Planning Application No. A/K5/878
Section 16 Planning Application for Proposed Minor Relaxation of Building Height Restriction
for Permitted 'Religious Institution' and 'Social Welfare Facility' Uses,
at NKIL Nos. 3635 RP and 3762, 43 - 45 Berwick Street, Sham Shui Po, Kowloon

Submission of Further Information

**Section 16 Planning Application for Proposed Minor Relaxation of
Building Height Restriction for Permitted 'Religious Institution'
and 'Social Welfare Facility' Uses, at NKIL Nos. 3635 RP and 3762,
43 - 45 Berwick Street, Sham Shui Po, Kowloon**

Responses-to-Comments

Figure 5 Proposed Vehicular Access and Footpath Widening

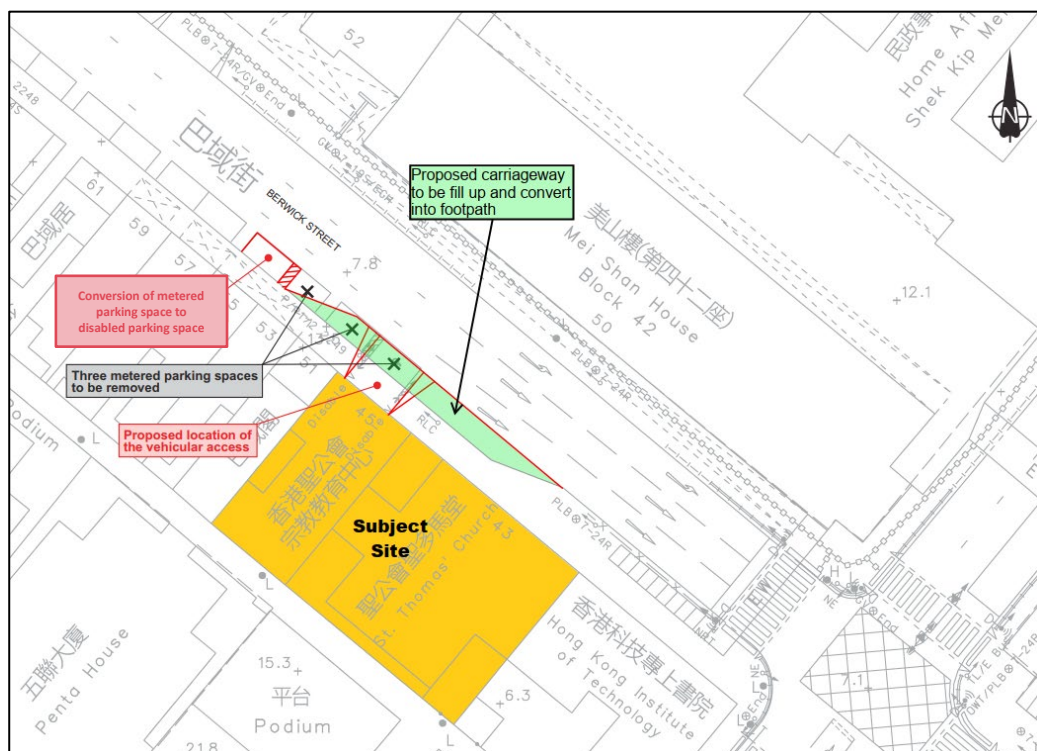
10.	Figure 5 – For the sake of clarity, please review if the annotation of 'Proposed disabled parking space' should read as 'Conversion of metered parking space to disabled parking space'	Noted and updated accordingly. Replacement pages of the Planning Statement are in Annex 1 .

DRAWING NO : FIGURE 3-1 REVISION : 1

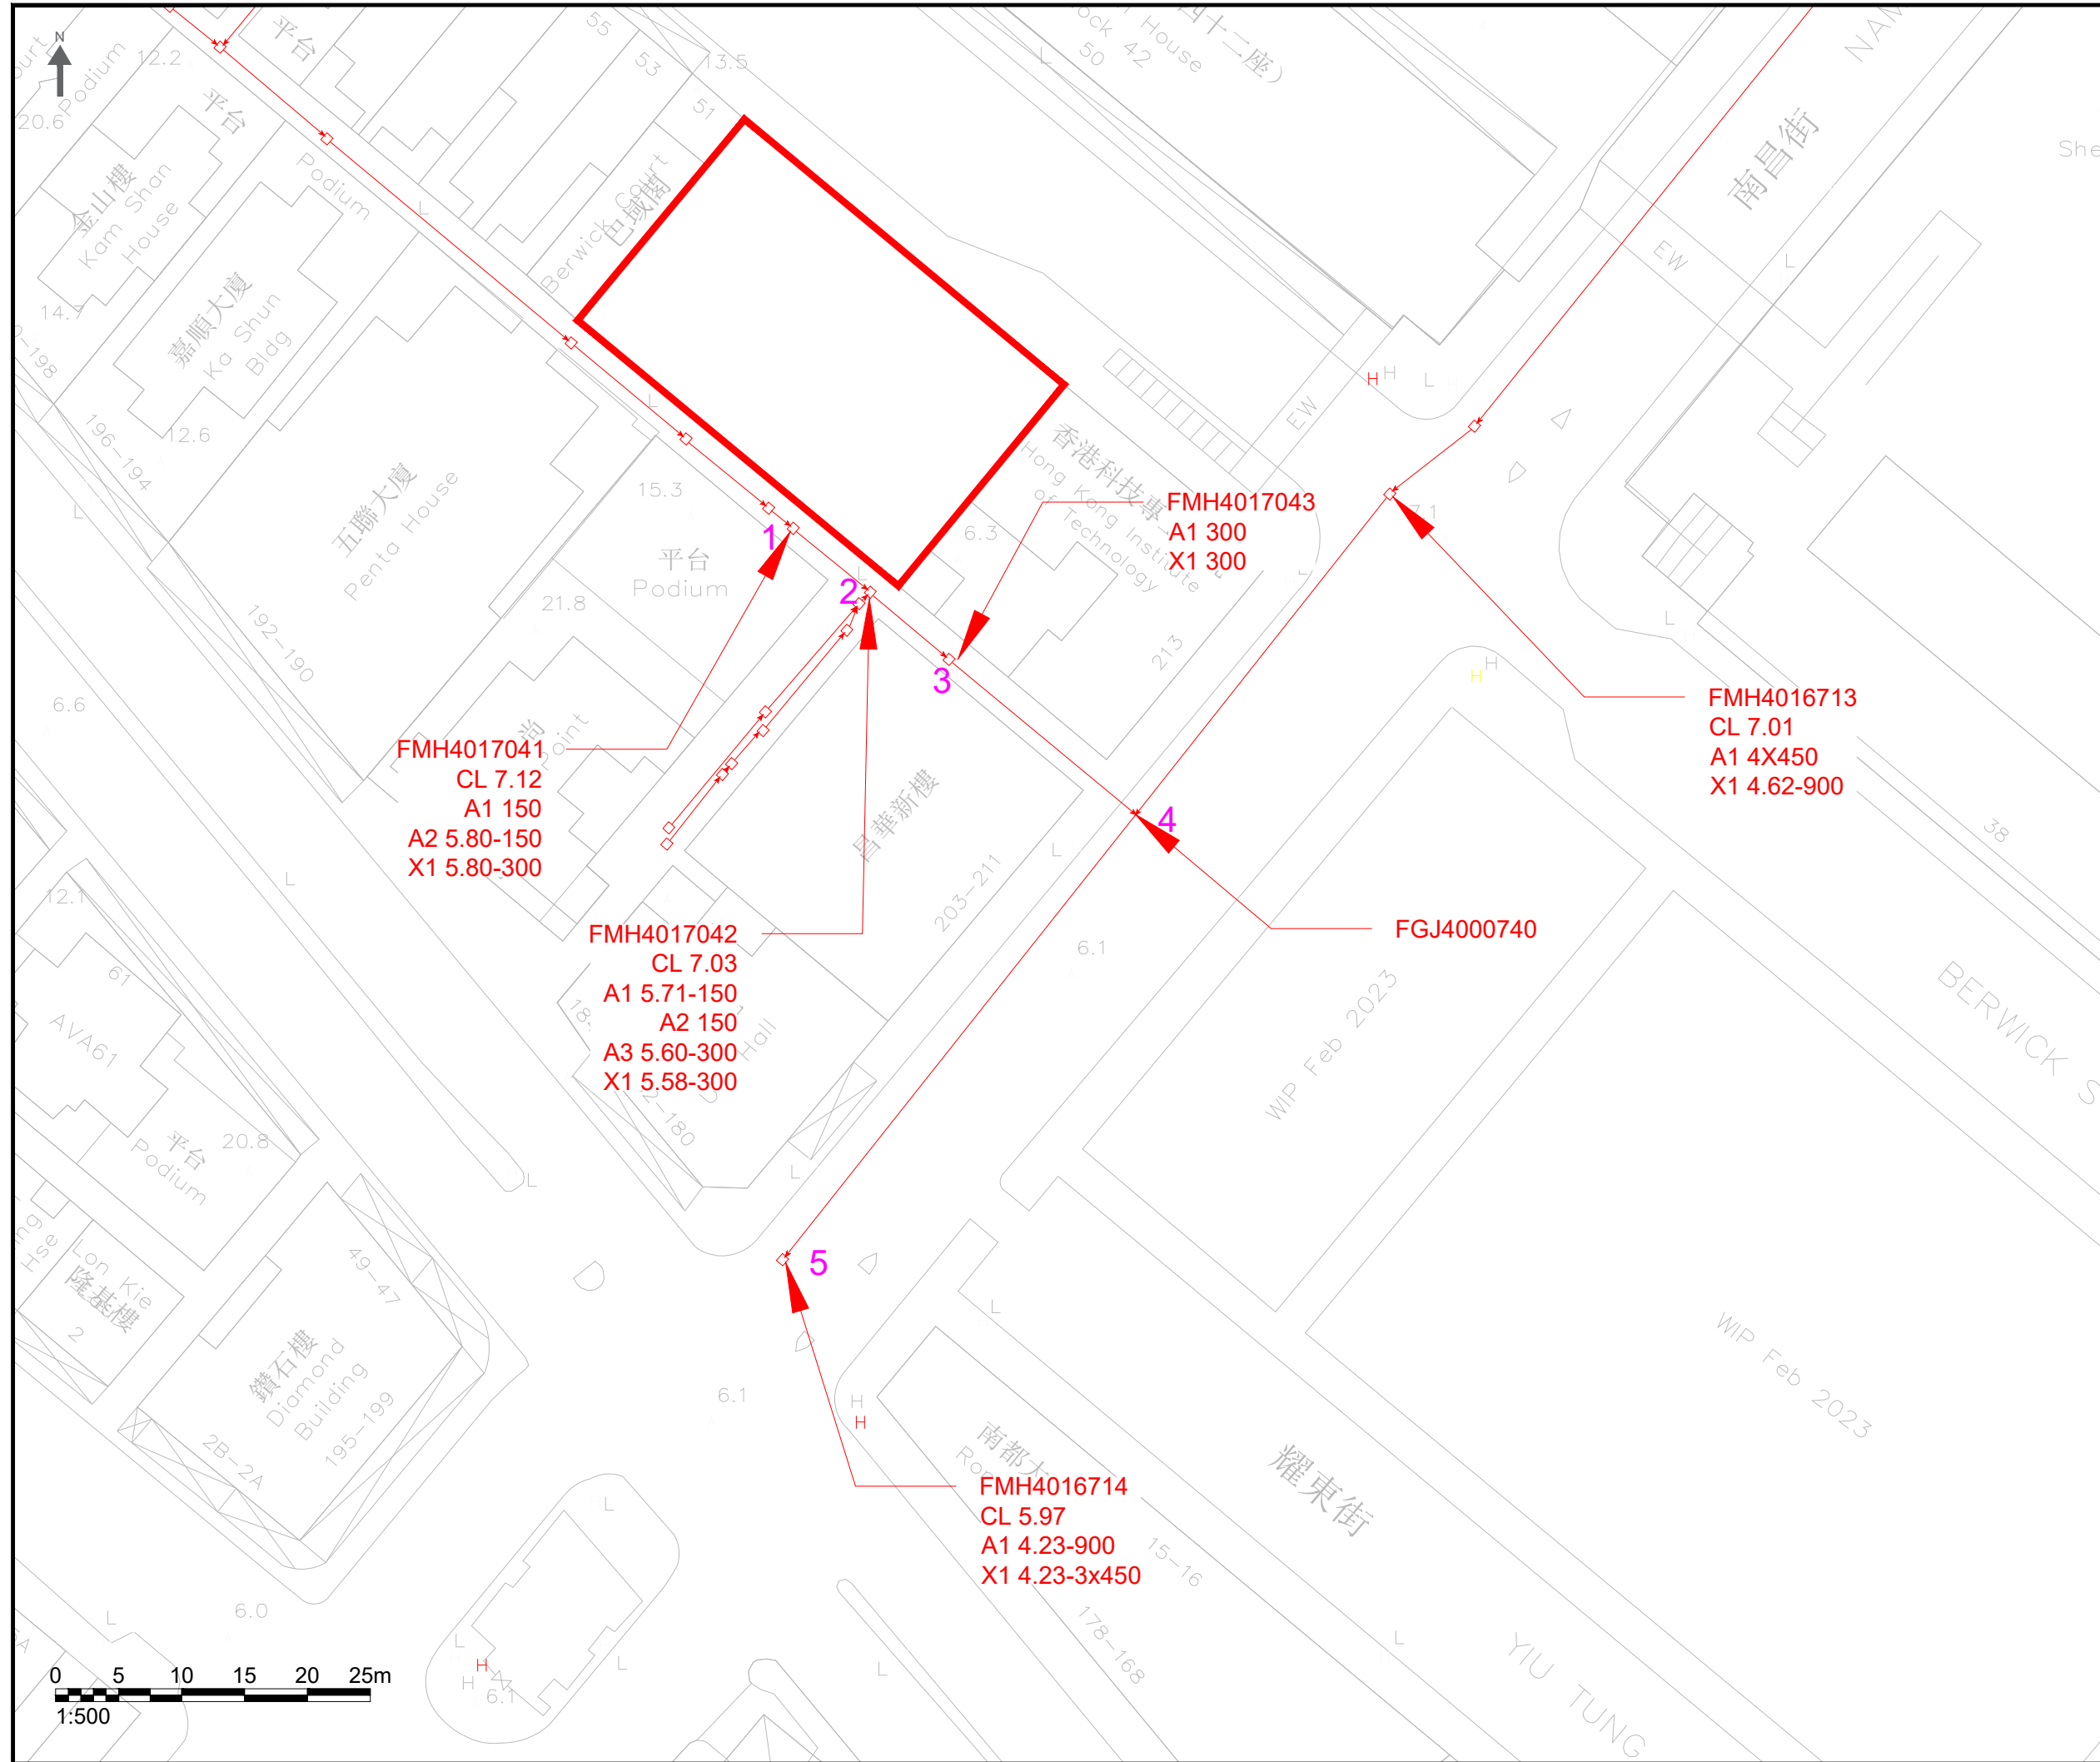
10.	It appears that the proposed development will not contribute to the sewage flow of sewer segment between manholes FMH4016713 and FGJ4000740, please remove the information "Project Site Peak Flow Occupancy, 0.2%" in Appendix 7-1 for factual correctness.	Noted, Appendix 7-1 and Table 7-1 have been updated accordingly. Please refer to the replacement pages of SIA in Annex 3 of this FI submission.

G/F Plan | Proposed Extent of Footpath Widening [1:150] (*For Indicative and Illustrative Purposes Only)

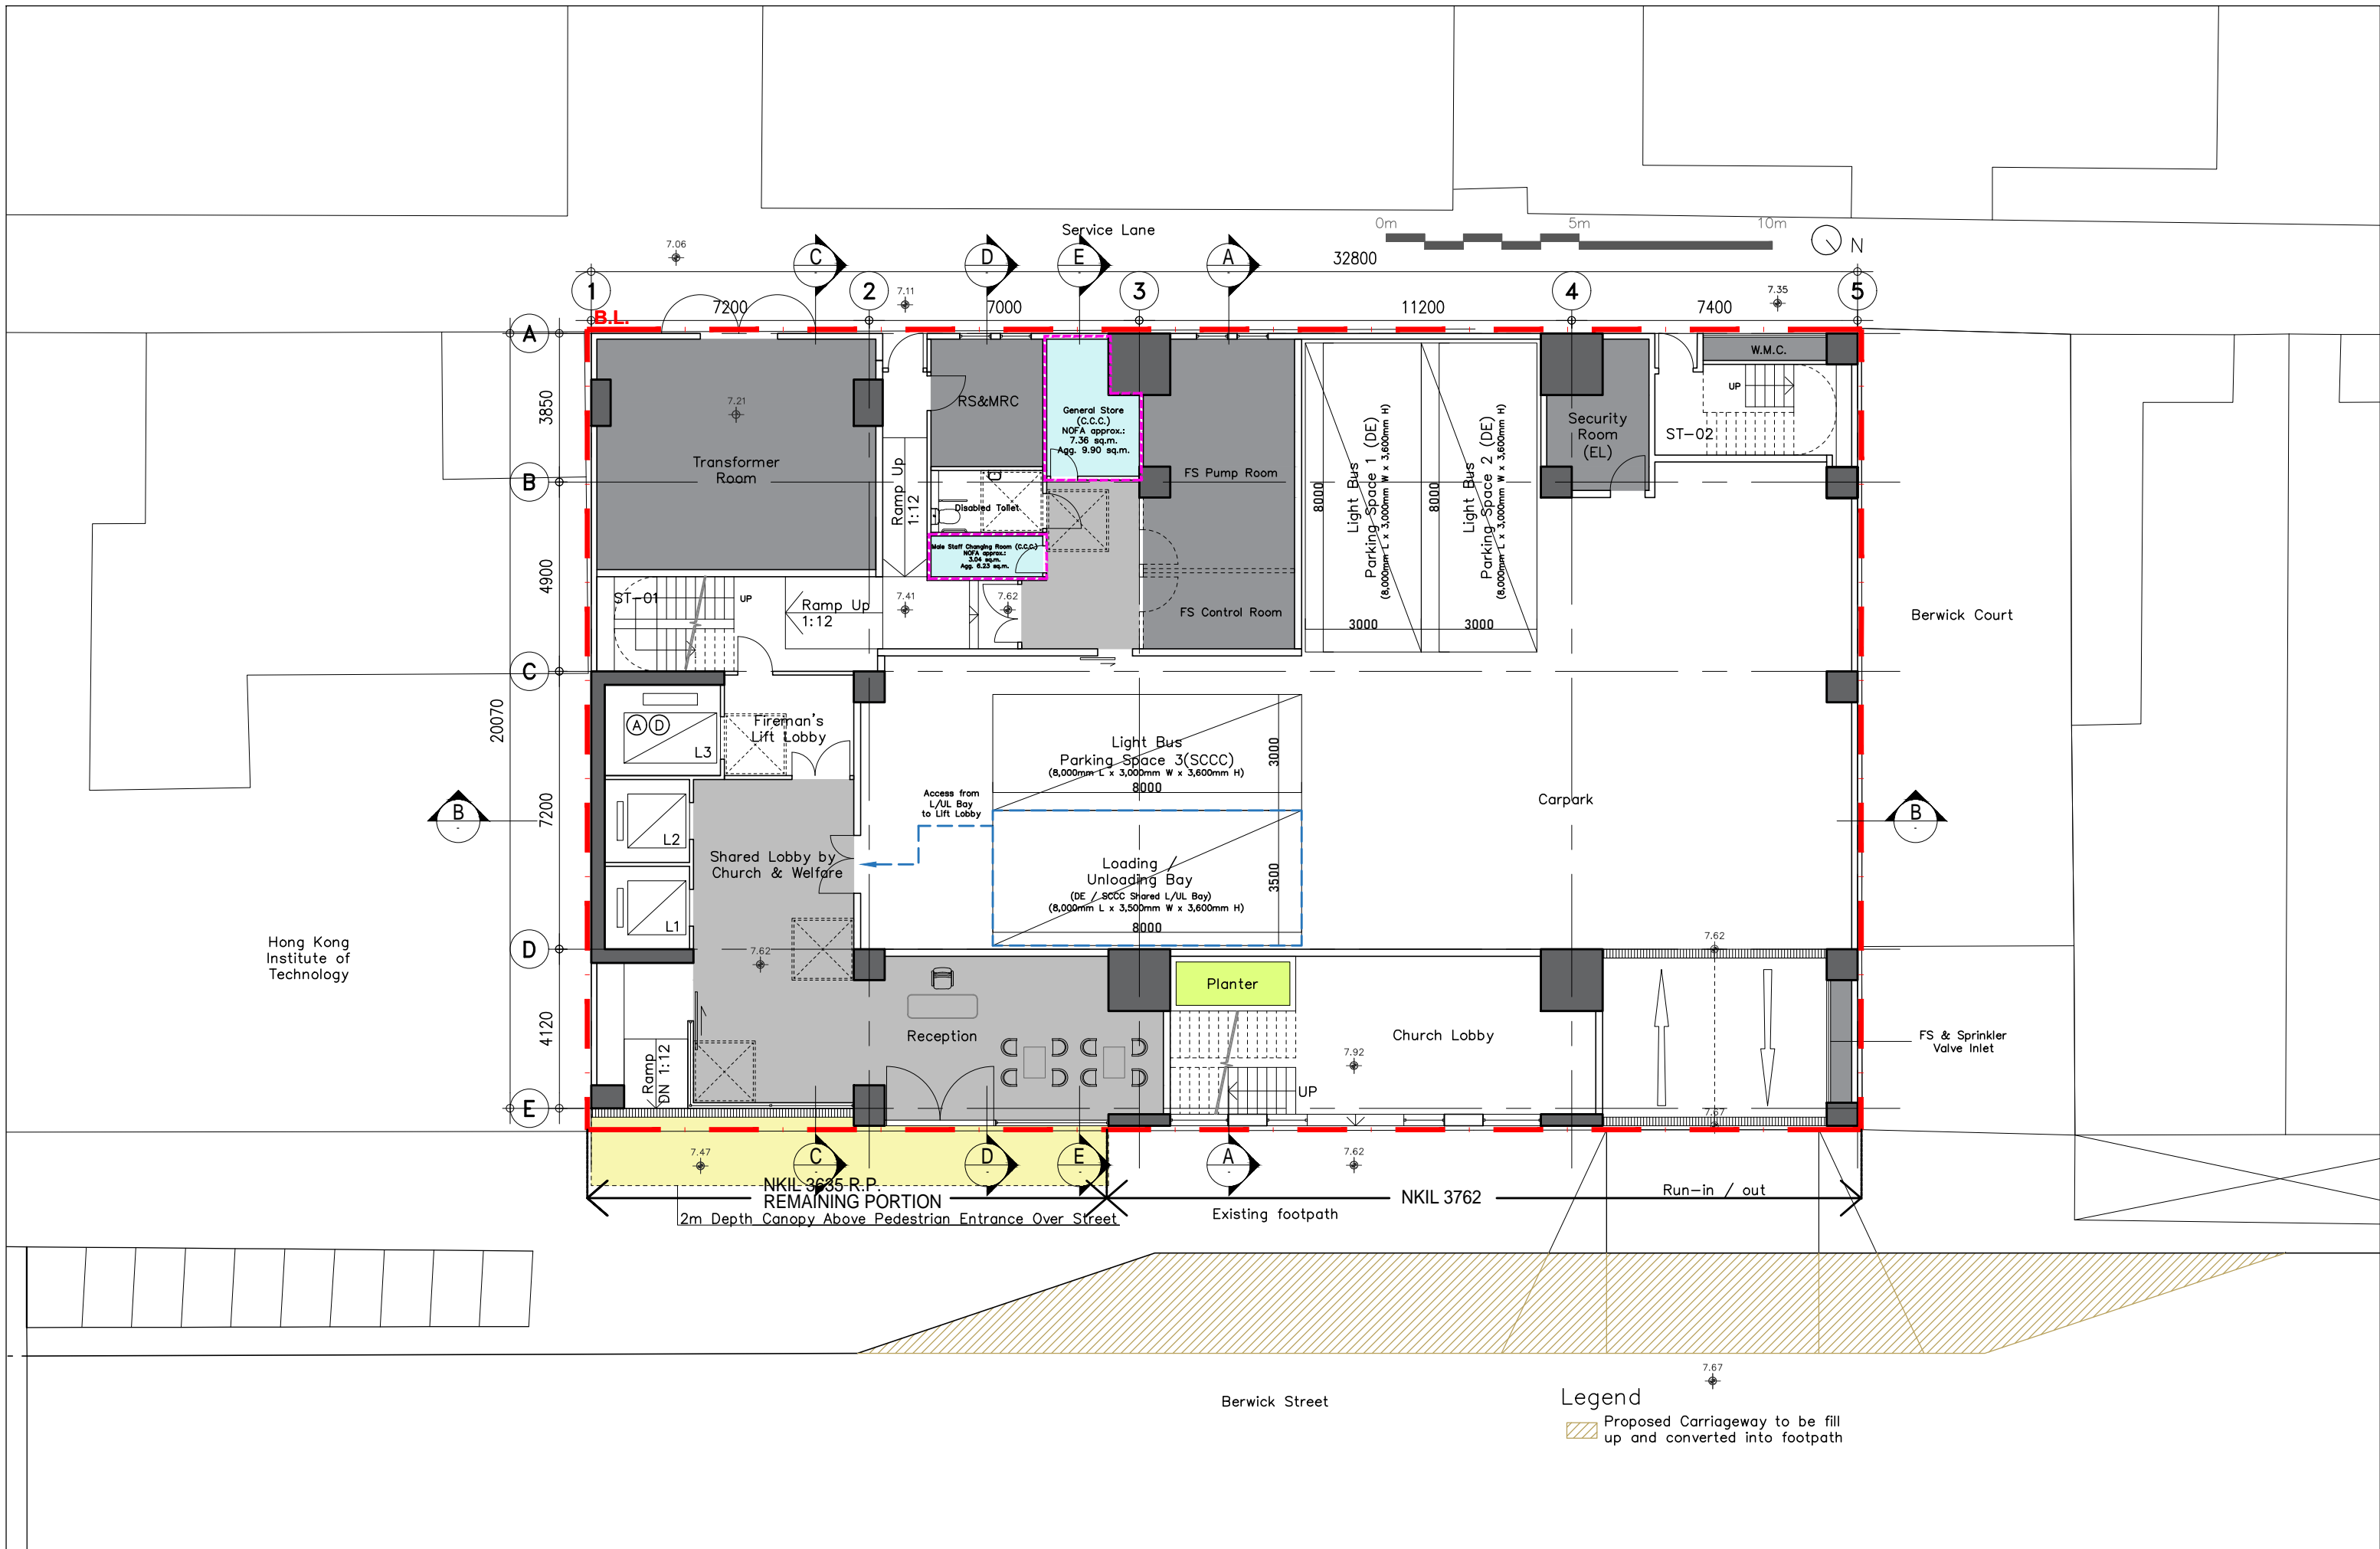
13.	Drawing on "Artist's Impression on Footpath Widening of Portion of Berwick Street fronting the Application Site" – Please highlight the extent of footpath widening proposal on the plan.	Noted and revised. Please refer to Annex 4 of this FI submission.
Annex 3 - Landscape Drawings
